DEPARTMENT OF ENVIRONMENTAL MANAGEMENT

Re: Application No. 9906-1690

ISDS REVIEW COMMENTS: 9906-1690

SUMMIT STORE.
 Assessor's Plat 316/Lot 27

PRECAST GREASE TRAP
1,000 GALLONS
GREASE TRAP TO WITHSTAND HS-20 WHEEL LOADS
USE CAST IRON FRAMES AND COVERS

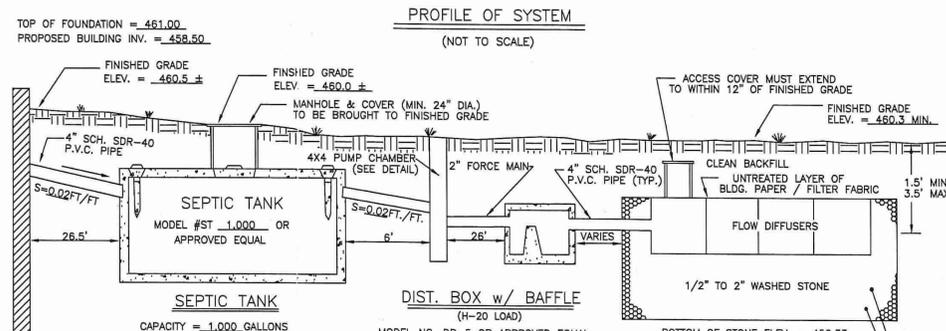
③ Provide inverts for grease trap;

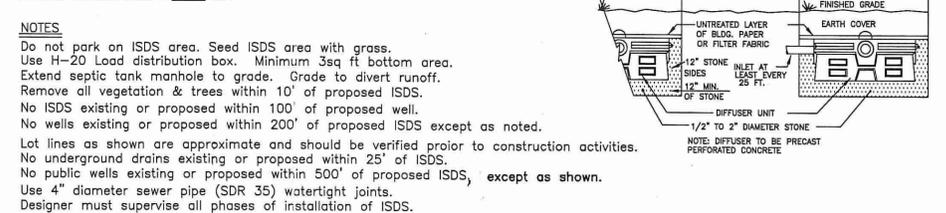
④ Correct depth of stone shown on PD cross section;

⑤ Provide PD typical to withstand HS-20 wheel loads
